Addendum No. 2
October 16, 2023

Project: **Harrisburg South Middle School Theatre Addition**
Harrisburg, South Dakota
Architecture Incorporated Project #3024

Scope of this Addendum:

4) DRAWING 2.22 – SITE PLAN

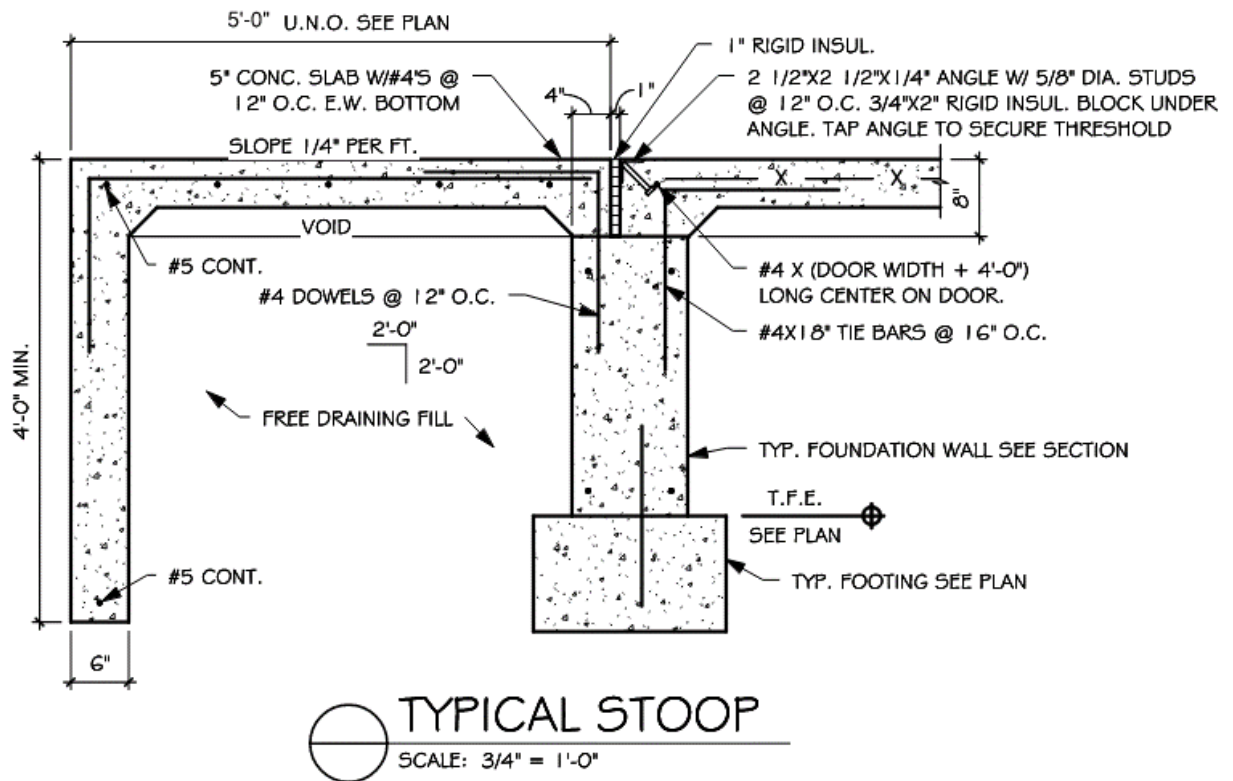
- a) Where '**RELOCATED FLAG POLE**' is noted on the plan, the existing flagpole is to be salvaged and reinstalled in a new flag pole base per detail below.

- b) Provide concrete stoops per detail below at all new exterior doors. Reference architectural and structural drawings for locations/additional information.

6) DRAWING 2.31 – CIVIL SITE/SURFACING PLAN

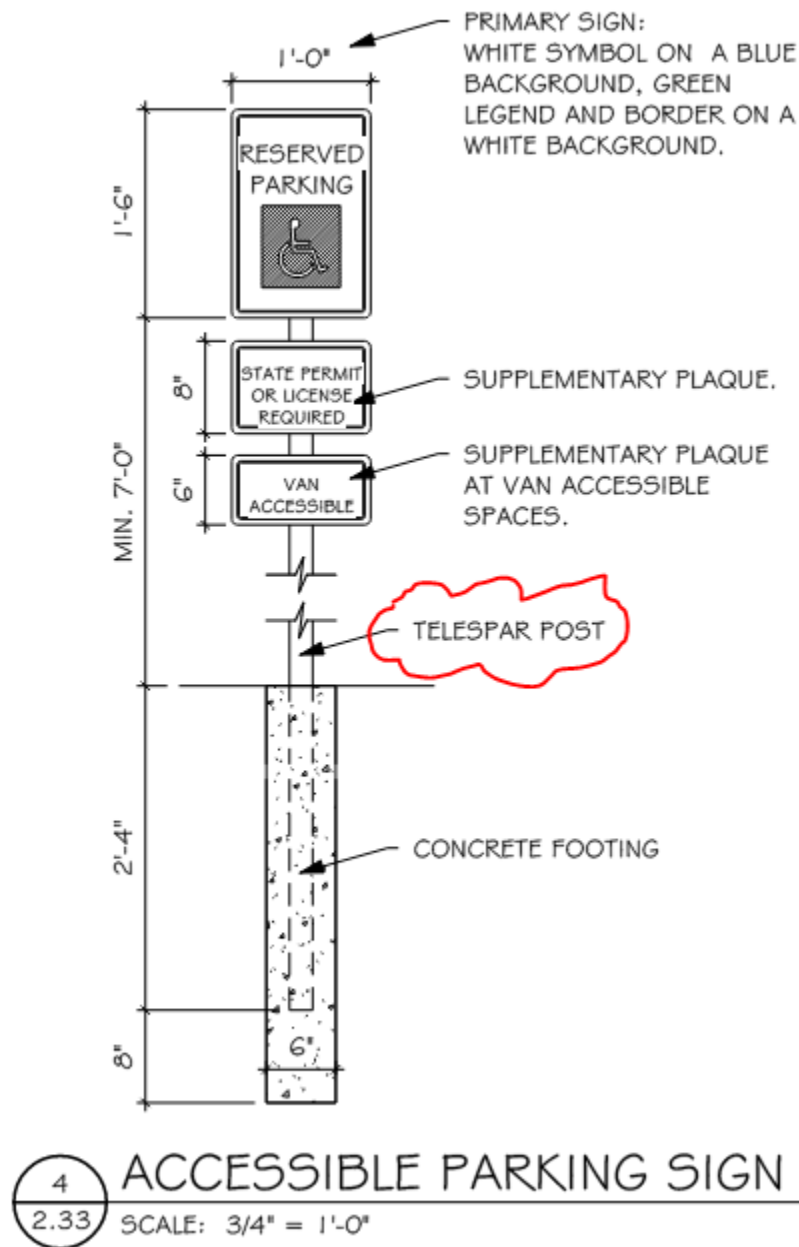
- a) ADA signage types A & B – Provide type '*A*' **VAN ACCESSIBLE** at all four ADA parking spaces shown on this plan. (Omit reference to type '*B*' **ACCESSIBLE HANDICAP SIGN**). Provide '**TELESPAR**' post as noted below.

14) SHEET 3.53 – DETAILS – PRECAST

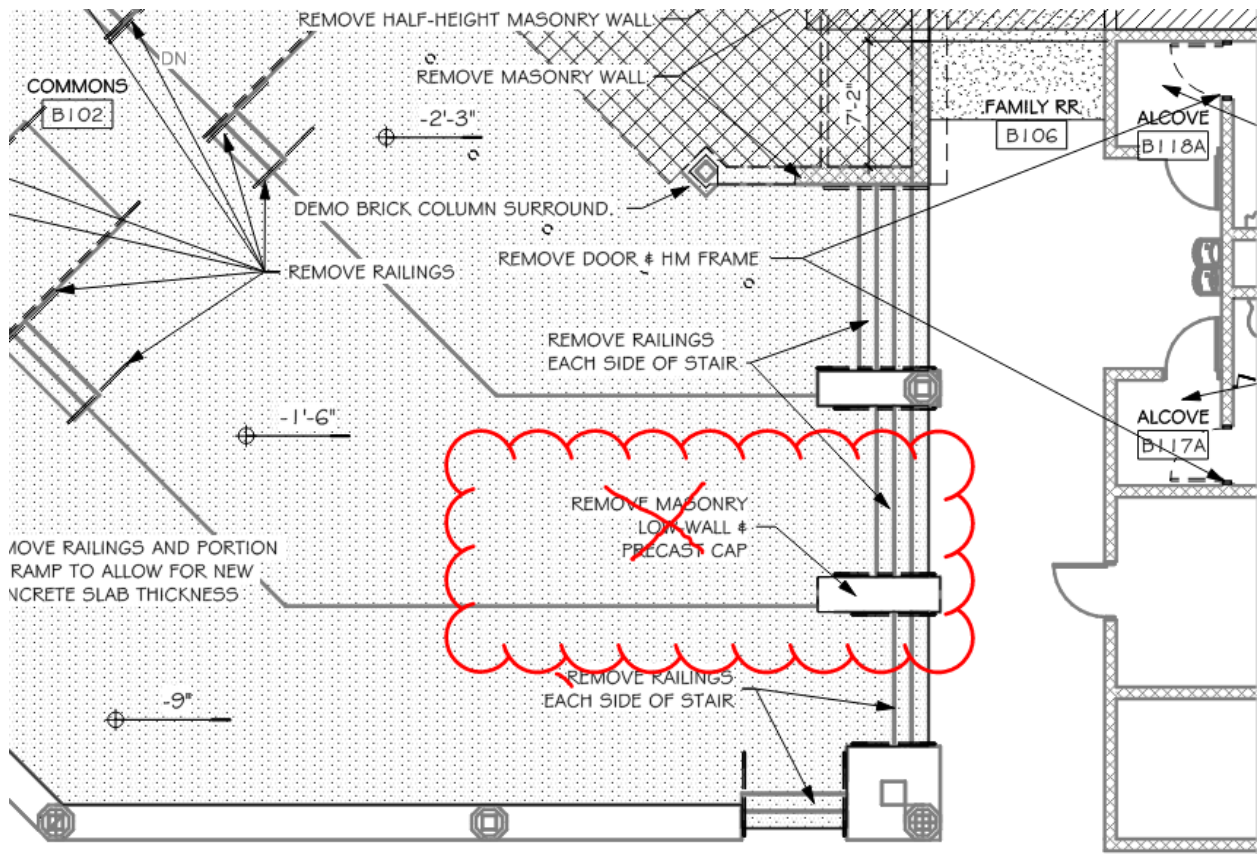
- a) DETAIL 9: Connect hangers per revised sheet.

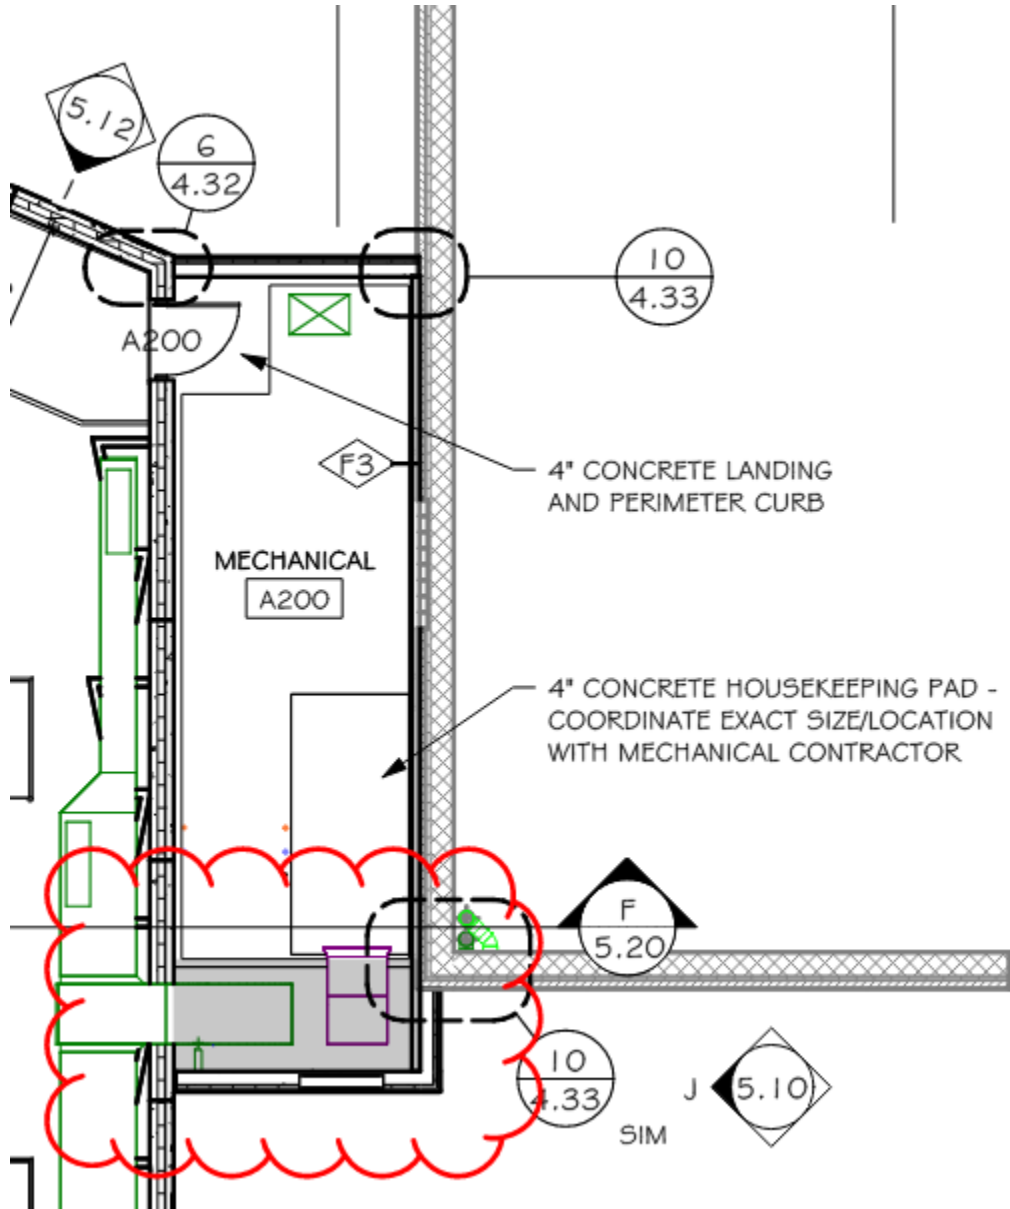
- f) Where new 8" steel columns occur in new or existing 8" concrete block walls, provide detail 2/4.10A as shown on attached revised sheet 4.10A dated 10-16-23. Reference structural drawings for locations.

25) DRAWING 5.44 – SECTION DETAILS

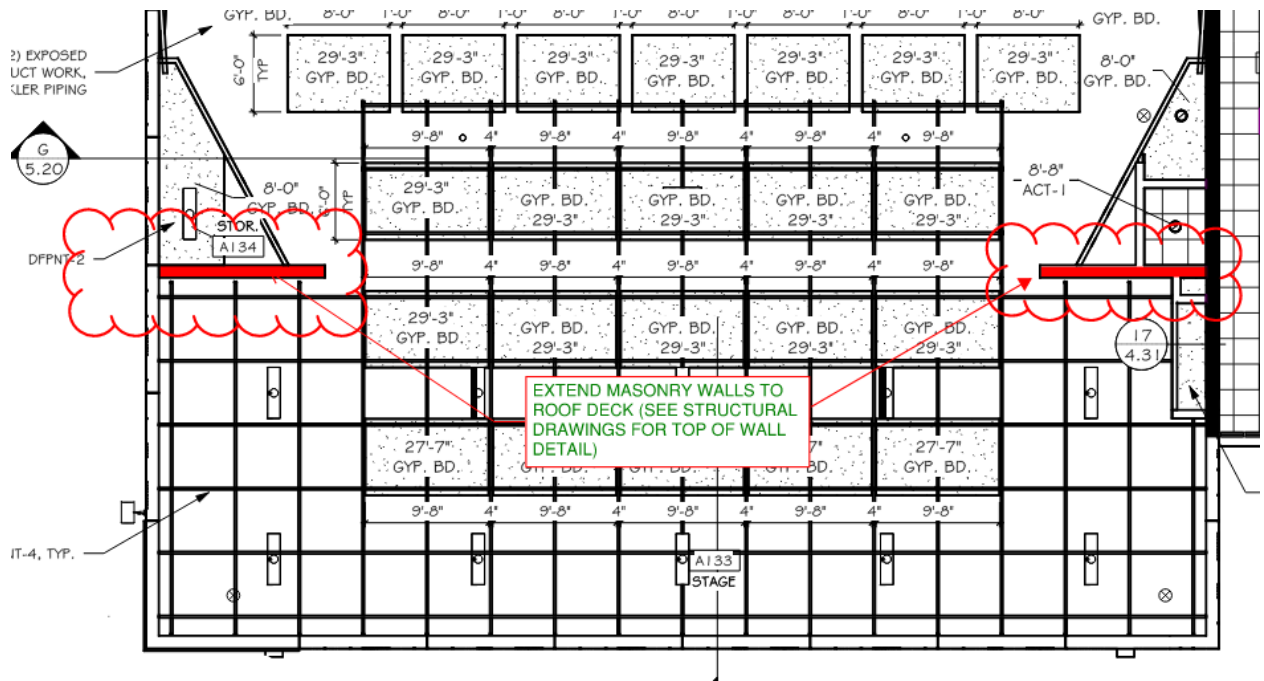
- a) At bench detail 2/5.44, provide ½” dia. rebar x 16” long at 16” o.c. Provide polished concrete on the top surface with acid etch finish on the vertical face. Benches shall be 7’-0” long with burnished block base 6’-8” long.

SITE DEMOLITION PLAN

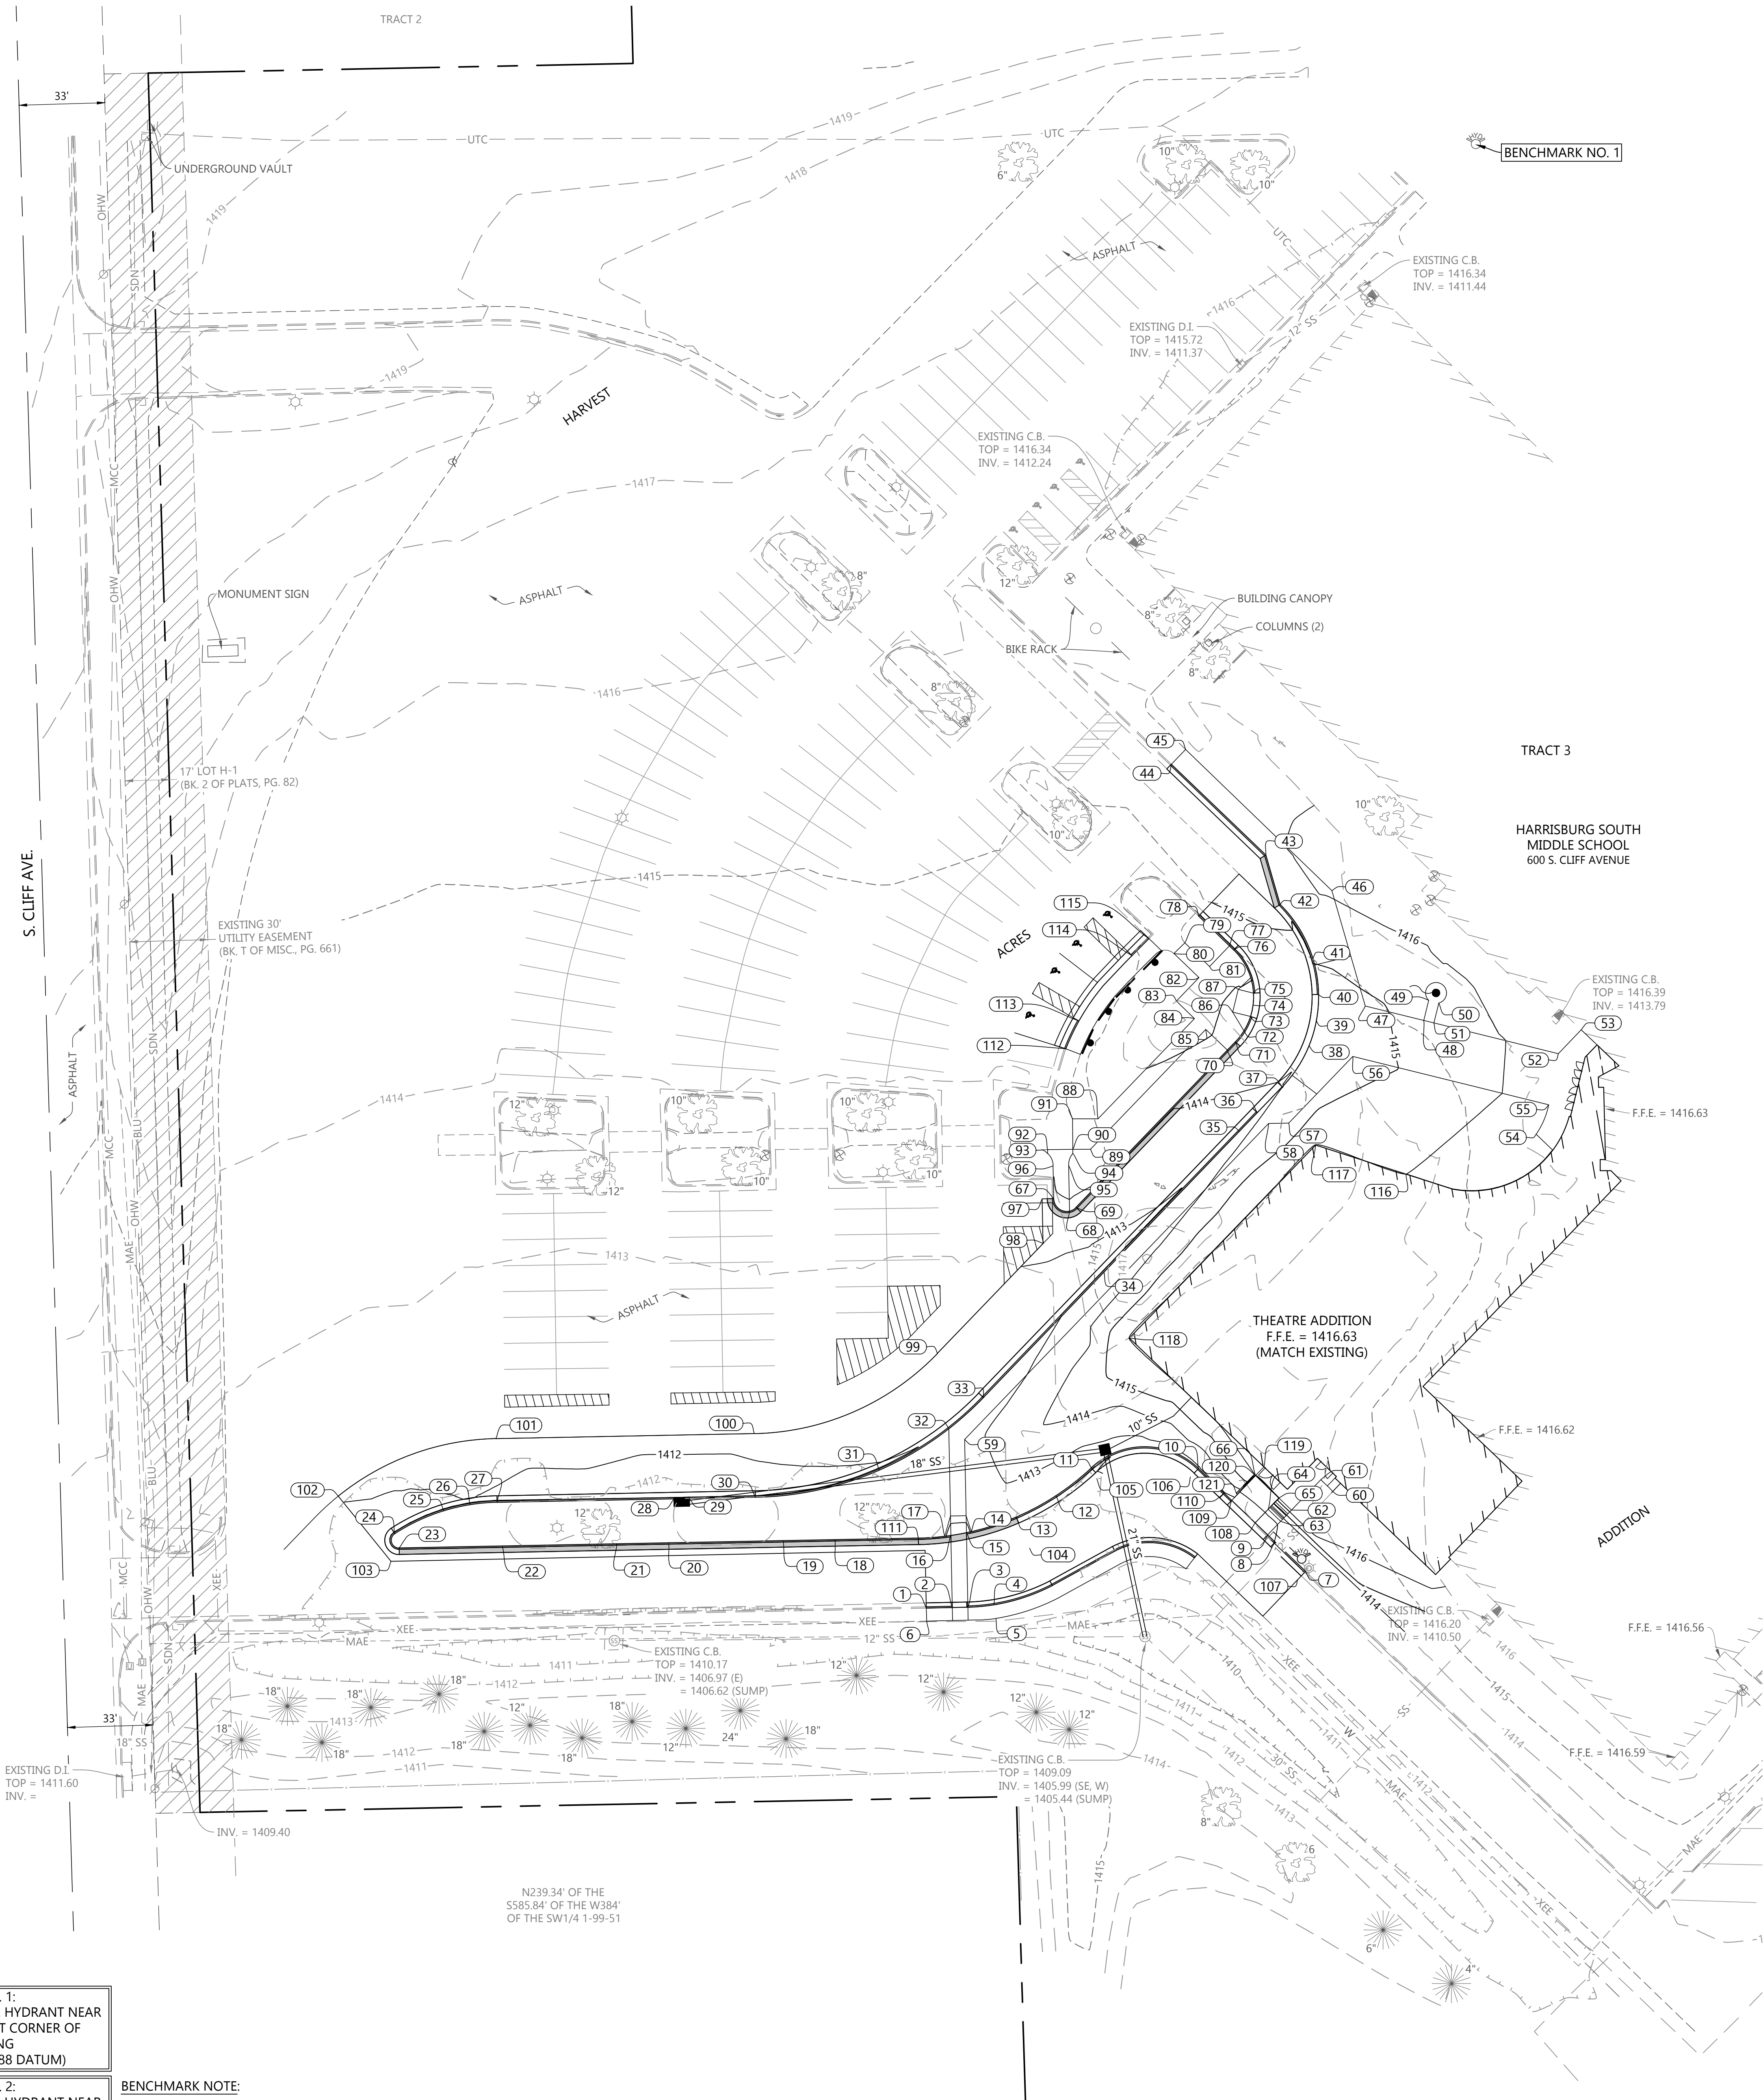
- a) See attached revised drawing 2.30 with revision date of 10-16-23 for clarification on demolition notes (clouded).
